SERVICE BULLETIN

N° **139-444**

REV. : C - June 28, 2018

ATA 78 - EXHAUST DUCTS AND REAR FIREWALL RETROMOD

Figure 17

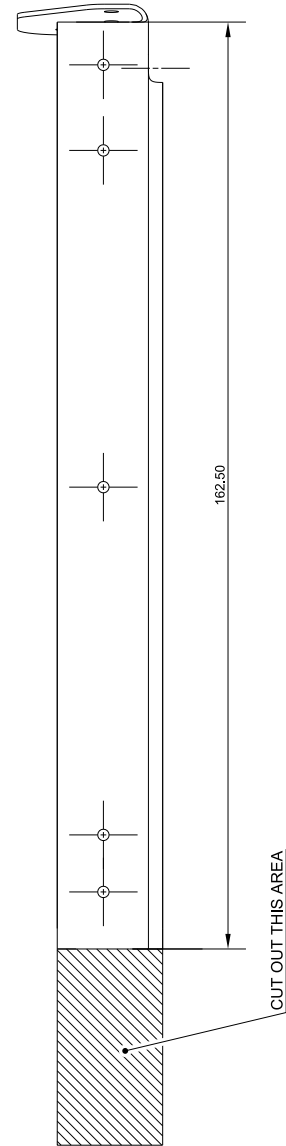
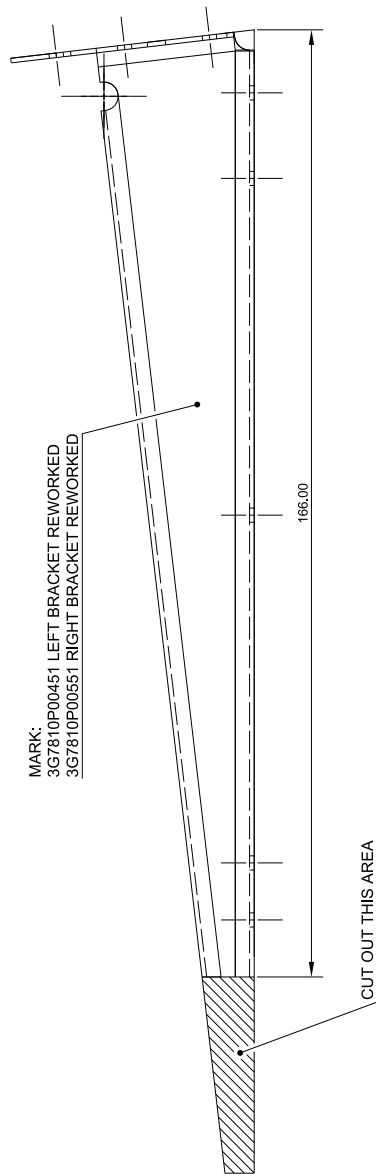
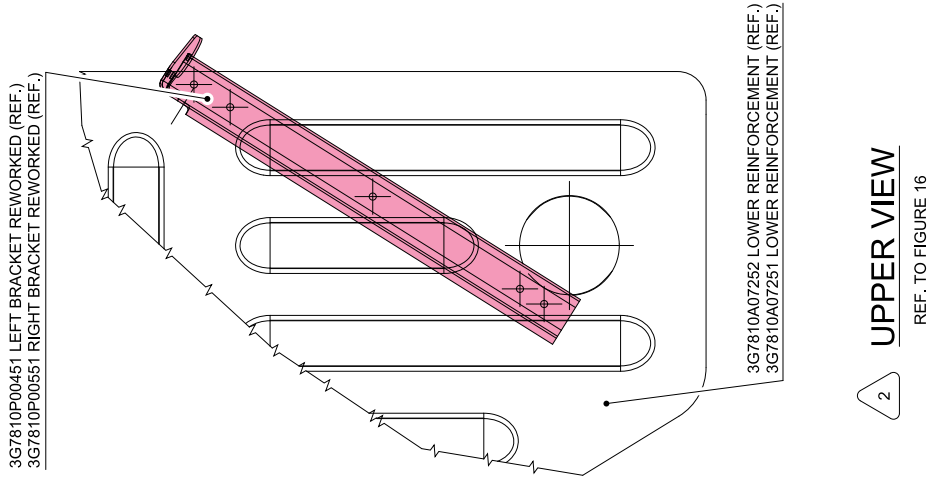
- 2.6 With reference to Figure 17, rework the lower bracket LH P/N 3G7810A04153 and lower bracket RH P/N 3G7810A05353 as follows:
 - 2.6.1 Perform cut out of the shaded area of the two lower brackets.

- 2.6.2 Mark P/N 3G7810P00451 on the reworked lower bracket LH and P/N 3G7810P00551 on the reworked lower bracket RH by means of an indelible pen.
- 2.7 With reference to Figure 17 upper view, temporarily locate reworked lower bracket LH P/N 3G7810P00451 and reworked lower bracket RH P/N 3G7810P00551. Countermark position of n°10 rivet holes.

- 2.8 With reference to Figure 17 upper view, drill n°10 rivet holes $\varnothing 3.18 \div 3.43$ in the previously marked positions.
- 2.9 With reference to Figure 18 section K-K and Figure 16 section P-P, install reworked lower bracket LH P/N 3G7810P00451 and reworked lower bracket RH P/N 3G7810P00551 to rear ejector module and to pipe ring by means of n°14 rivets P/N MS20615-4M4.

Figure 20

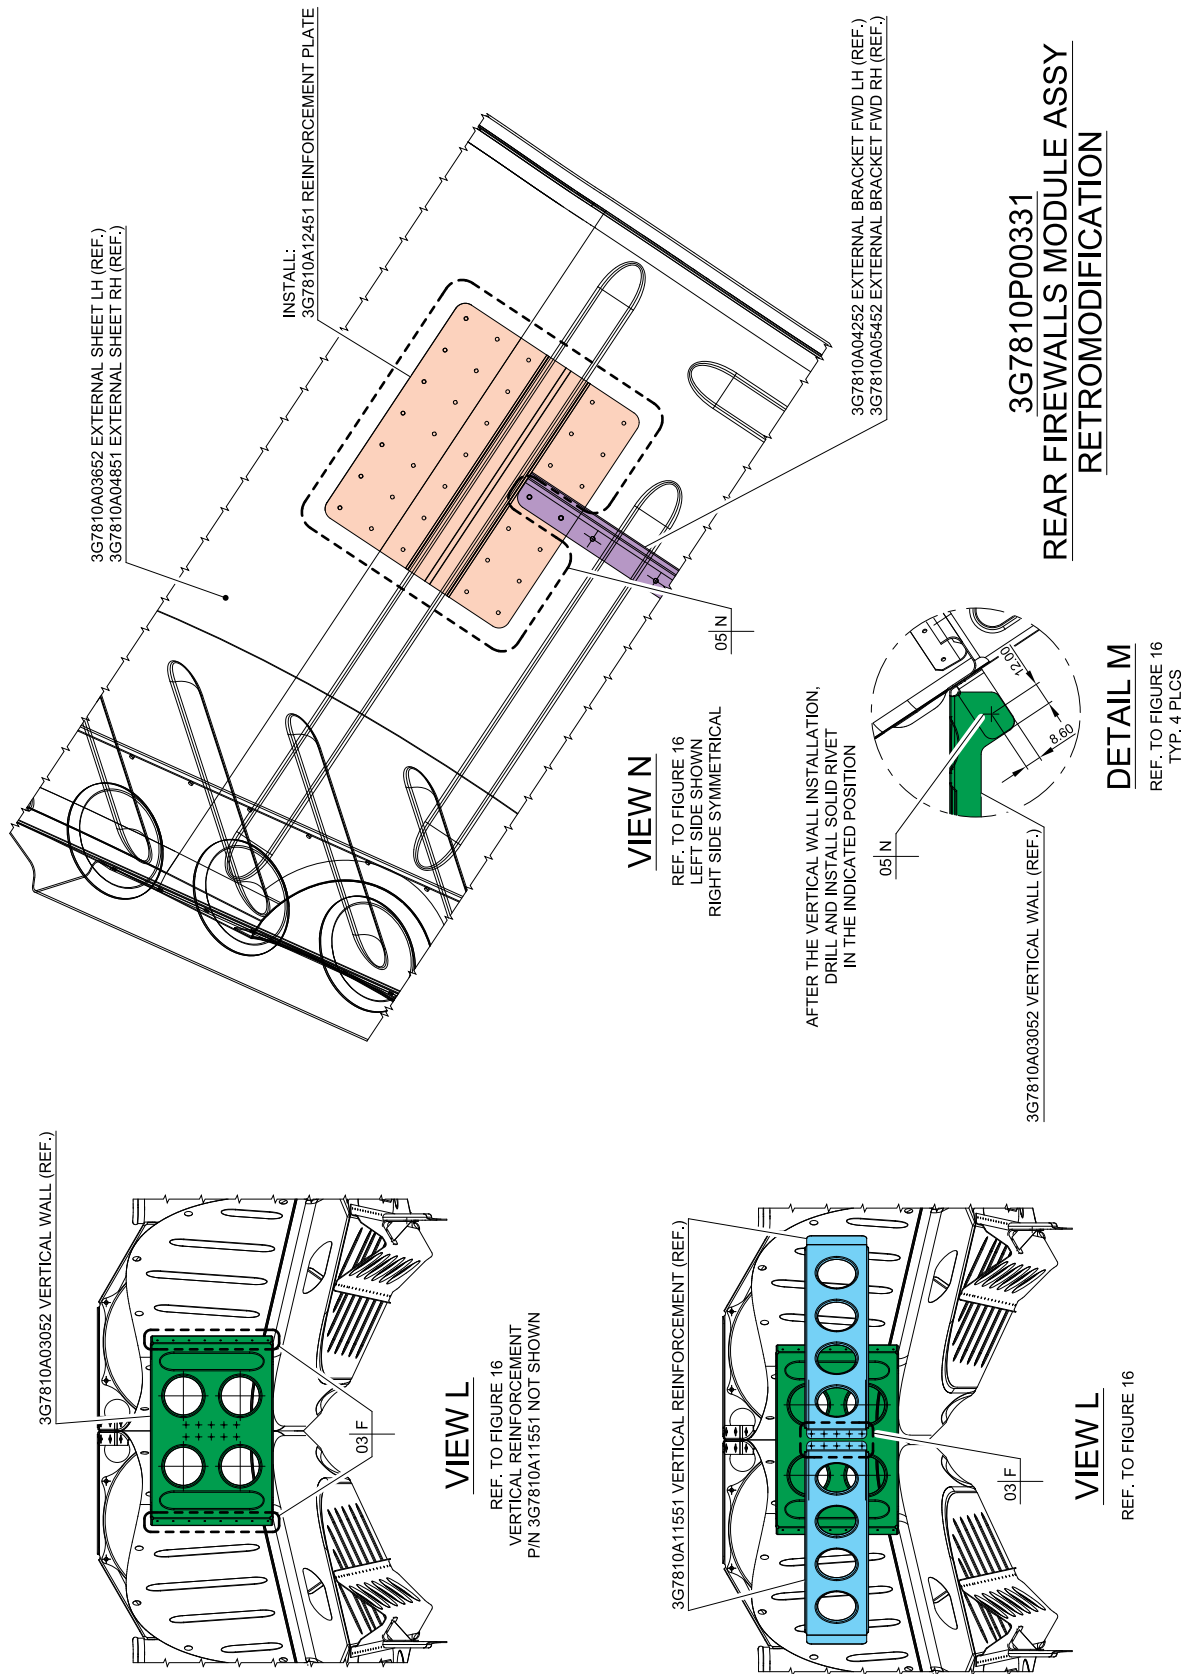
- 2.3 With reference to Figure 20 view N, temporarily locate n°2 reinforcement plate P/N 3G7810A12451, external bracket FWD LH P/N 3G7810A04252 and the external bracket FWD RH P/N 3G7810A05452. Countermark position of n°88 rivet holes in the rear ejector module.
- 2.4 With reference to Figure 20 view N, drill n°66 rivet holes $\varnothing 2.36 \div 2.62$ and n°22 rivet holes $\varnothing 3.18 \div 3.43$ in the previously marked positions.
- 2.5 With reference to Figure 16, Figure 18 section C-C and Figure 20 view N, install n°2 reinforcement plate P/N 3G7810A12451, one external bracket FWD LH P/N 3G7810A04252 and one external bracket FWD RH P/N 3G7810A05452 by means of n°66 rivets P/N MS20615-3M3 and n°22 rivets P/N MS20615-4M4.

- 2.24 With reference to Figure 20 view L, temporarily locate vertical wall P/N 3G7810A03052 and countermark positions of n°16 rivet holes in the rear exhaust module.

- 2.25 With reference to Figure 20 view L, drill n°16 rivet holes $\varnothing 3.18 \div 3.43$ in the previously marked positions.
 - 2.26 With reference to Figure 20 view L, install vertical wall P/N 3G7810A03052 by means of n°16 rivets P/N MS20615-4M4.

- 2.27 With reference to Figure 20 detail M, drill n°4 rivet holes $\varnothing 2.36 \div 2.62$ in previously marked positions through vertical wall and rear exhaust module.

- 2.28 With reference to Figure 20 detail M, install n°4 rivets P/N MS20615-3M3 at position shown.

Figure 21

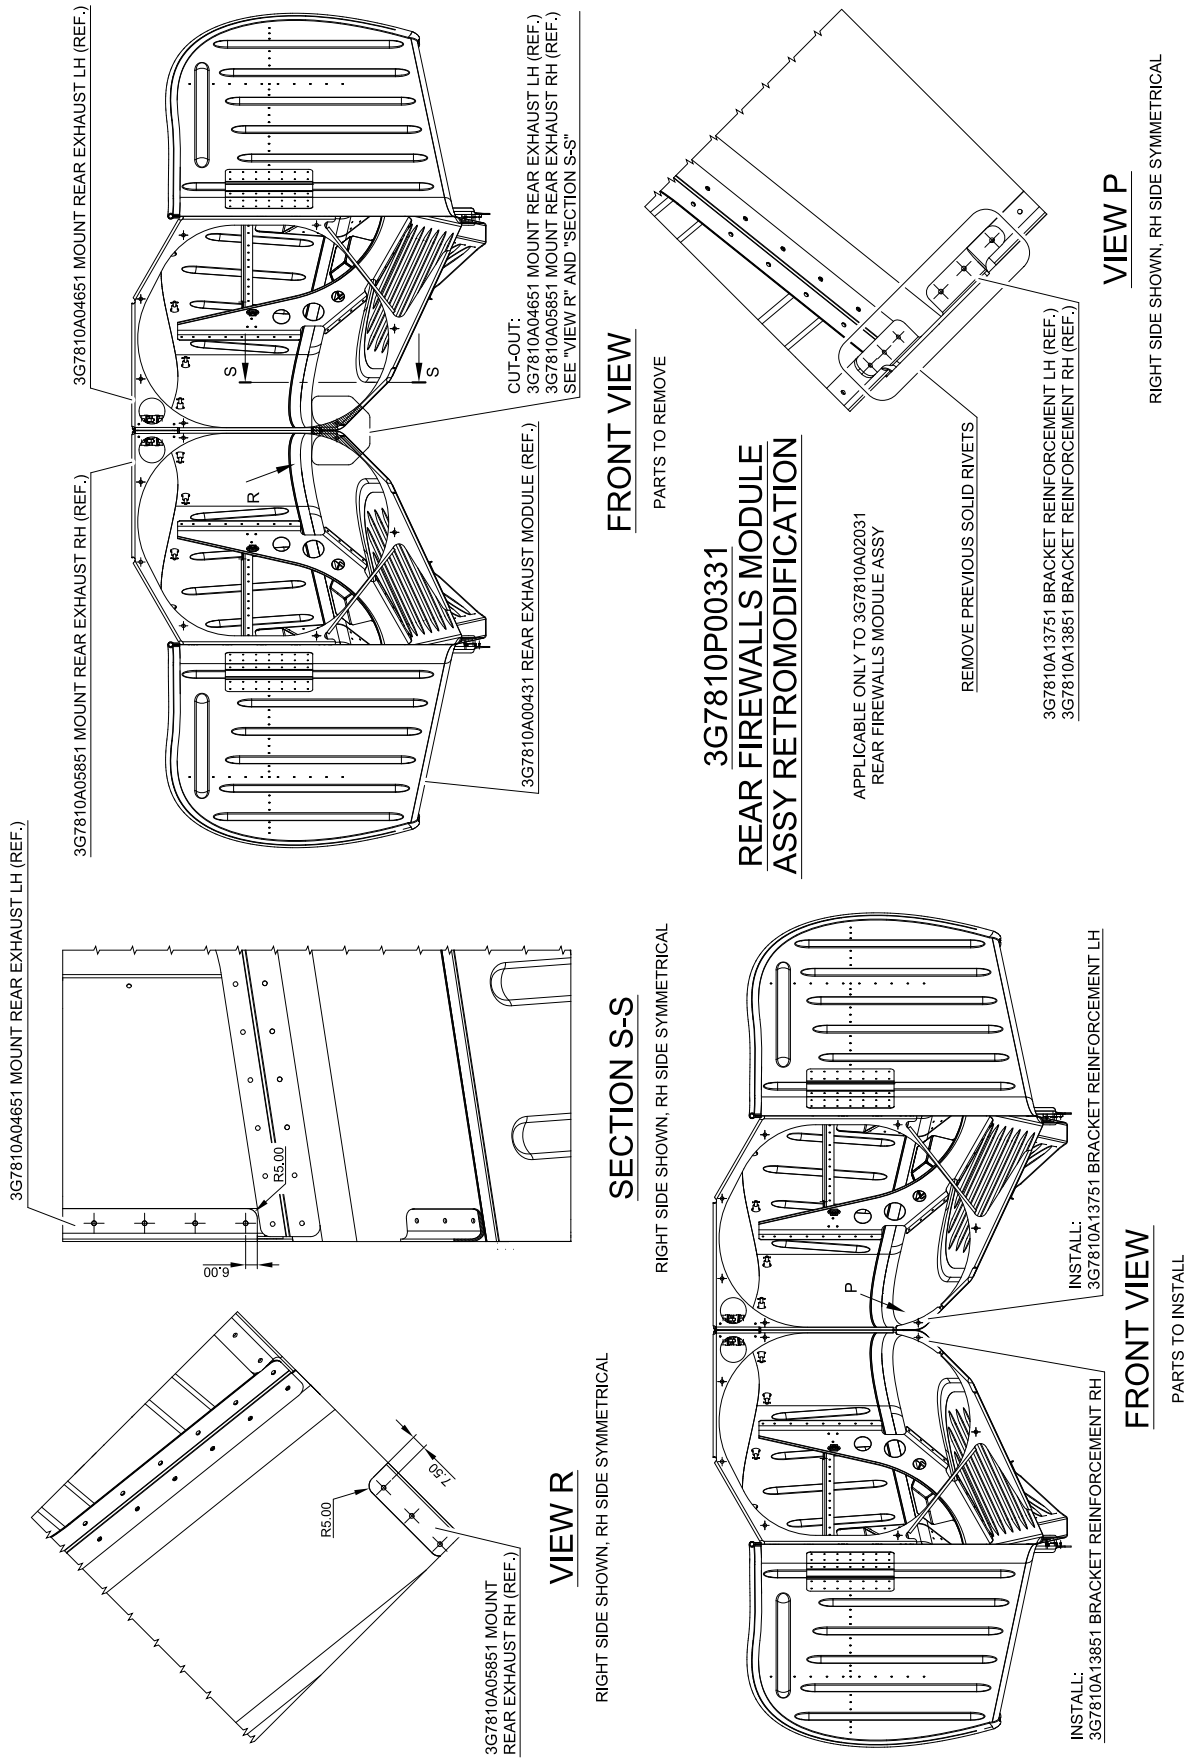
- 2.36 **Applicable only to rear firewall module assy P/N 3G7810A02031.** With reference to Figure 21, rework the forward side of the rear exhaust module as described in the following procedure:

- 2.36.1 With reference to Figure 21 view R and section S-S, cut out and rework the left mount rear exhaust P/N 3G7810A04651 and the right mount rear exhaust P/N 3G7810A05851 as shown.

- 2.36.2 With reference to Figure 21 view P, drill out the n°6 indicated existing rivets from the LH side and from the RH side.
 - 2.36.3 With reference to Figure 21 view P, temporarily locate the bracket reinforcement LH P/N 3G7810A13751 and the bracket reinforcement RH P/N 3G7810A13851 and countermark the position of the rivet holes on them.

- 2.36.4 Drill n°6 rivet holes \varnothing 3.18 ÷ 3.43 in the previously marked positions on bracket reinforcement LH P/N 3G7810A13751 and the bracket reinforcement RH P/N 3G7810A13851.
- 2.36.5 With reference to Figure 21 view P, install the bracket reinforcement LH P/N 3G7810A13751 and the bracket reinforcement RH P/N 3G7810A13851 by means of n°6 rivets P/N MS20615-4M5.
- 2.37 With reference to Figure 15, re-identify the reworked rear firewall module assy by means of an indelible pen as follows:
- Mark the P/N 3G7810A02033 as P/N 3G7810P00331.
 - Mark the P/N 3G7810A02031 as P/N 3G7810P00331R.

Figure 22

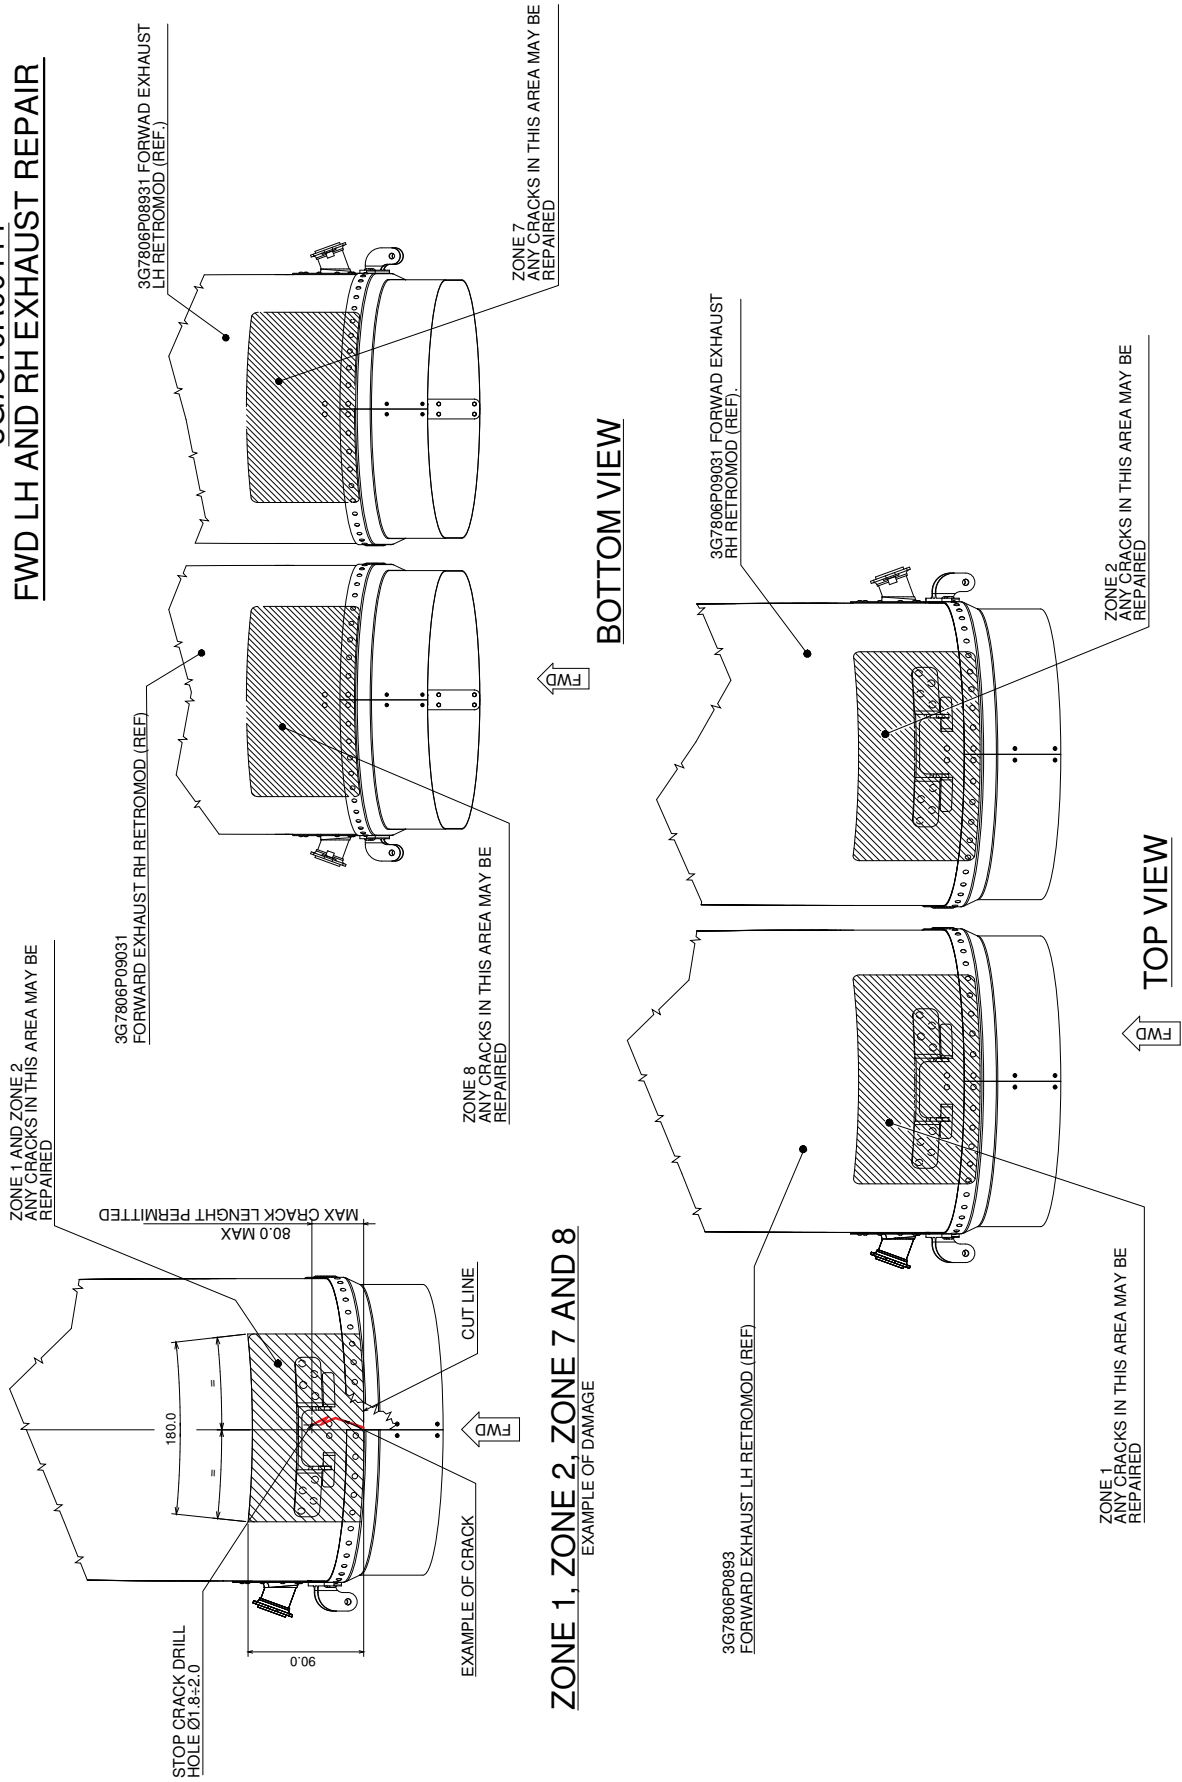
2. With reference to Figure 22 thru Figure 24, verify if cracks are in the areas and within the maximum dimension permitted.

Figure 25

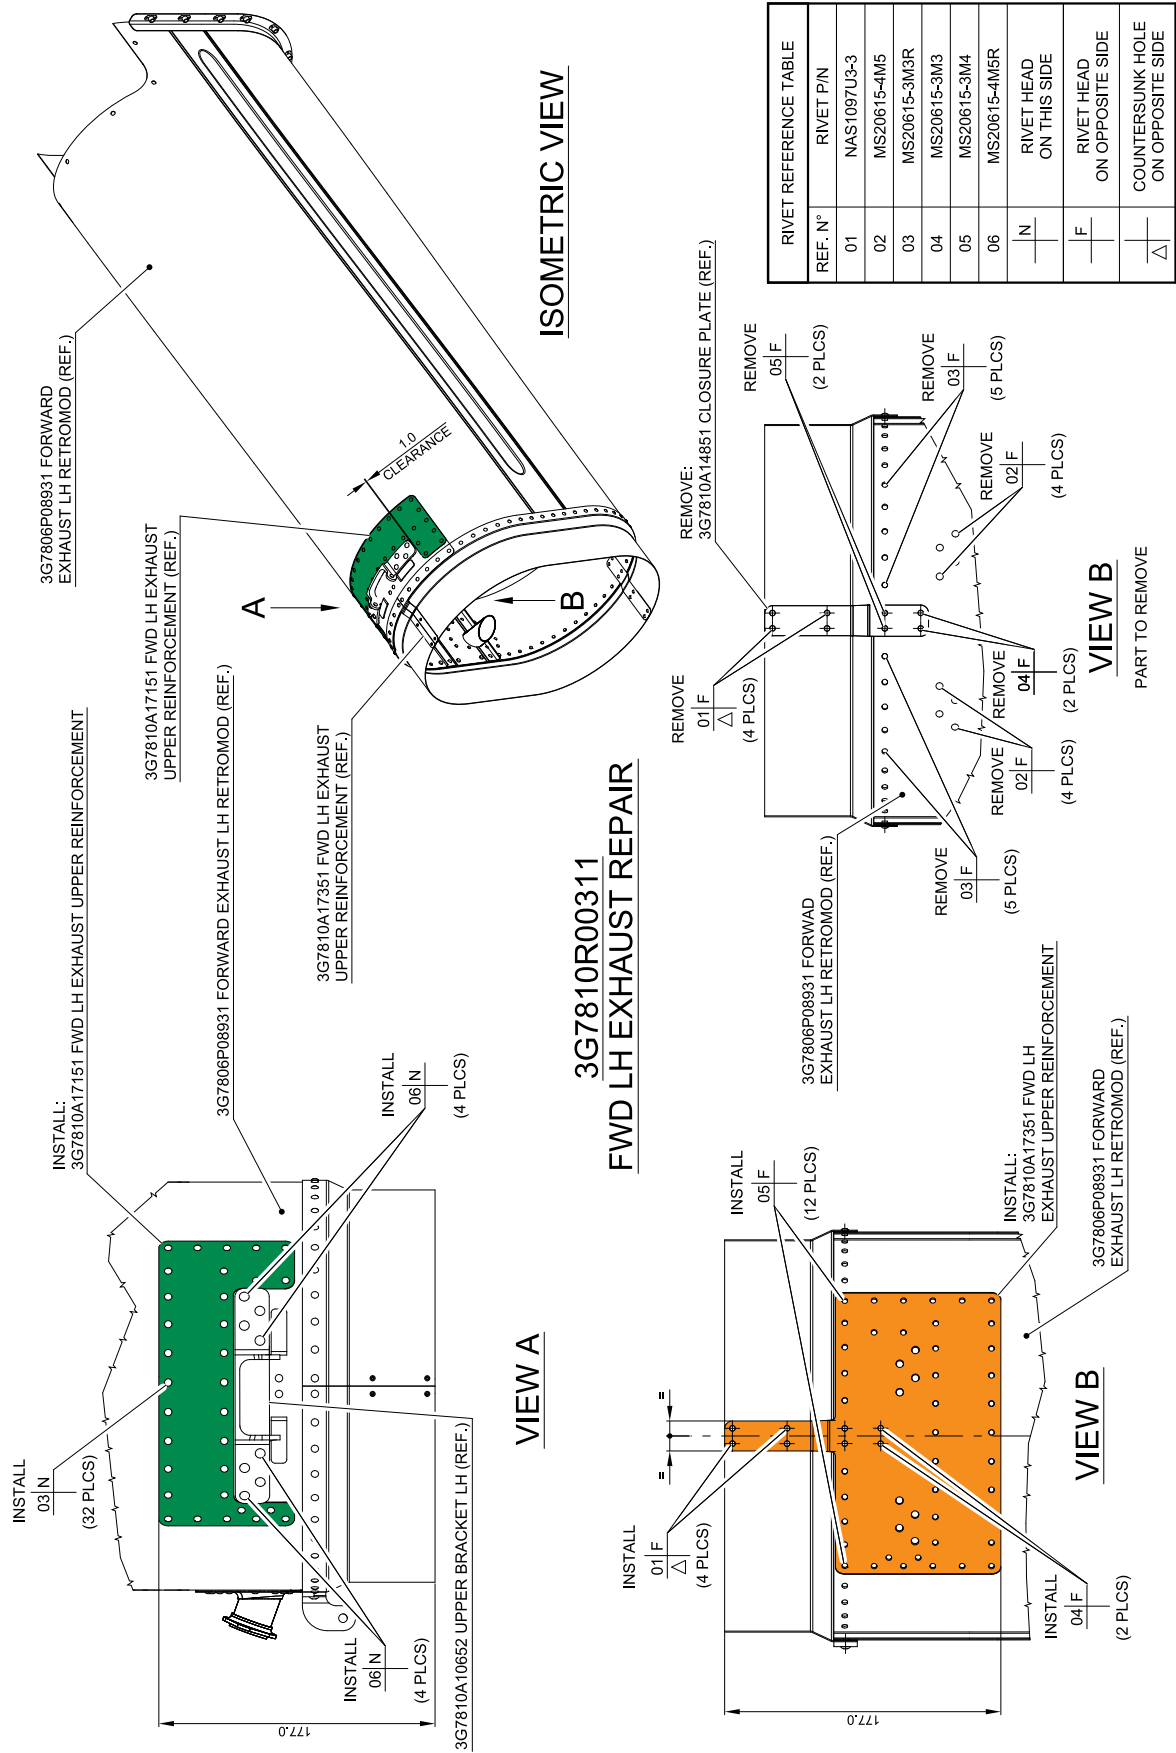
Retain the upper bracket LH P/N 3G7810A10652 for later reuse (ref step 3.1 and Figure 25 view A).

- 3.1 With reference to Figure 25 view B, drill out the indicated existing rivets and remove the closure plate P/N 3G7810A14851 from the forward exhaust LH.

- 3.2 With reference to Figure 25 view A, temporarily locate the FWD LH exhaust upper reinforcement P/N 3G7810A17151 on forward exhaust LH.
- 3.3 Using the FWD LH exhaust upper reinforcement P/N 3G7810A17151 n°32 pilot holes as a template, drill n°32 rivet holes $\varnothing 2.36 \div 2.62$ through the upper reinforcement and the forward exhaust LH.

- 3.4 With reference to Figure 25 view B, temporarily locate the FWD LH exhaust upper reinforcement P/N 3G7810A17351 inside the forward exhaust LH and countermark position of n°56 rivet holes on it.

- 3.5 With reference to Figure 25 view B, drill n°48 rivet holes $\varnothing 2.36 \div 2.62$ and n°8 $\varnothing 3.18 \div 3.43$ in the previously marked positions.

- 3.6 With reference to Figure 25 view A and view B, install the FWD LH exhaust upper reinforcement P/N 3G7810A17151 and the FWD LH exhaust upper reinforcement P/N 3G7810A17351 by means of n°32 rivets P/N MS20615-3M3R, n°12 rivets P/N MS20615-3M4, n°2 rivets P/N MS20615-3M3 and n°4 rivets P/N NAS1097U3-3.

- 3.7 With reference to Figure 25 view A, reinstall the upper bracket LH P/N 3G7810A10652 by means of n°8 rivets P/N MS20615-4M5R.
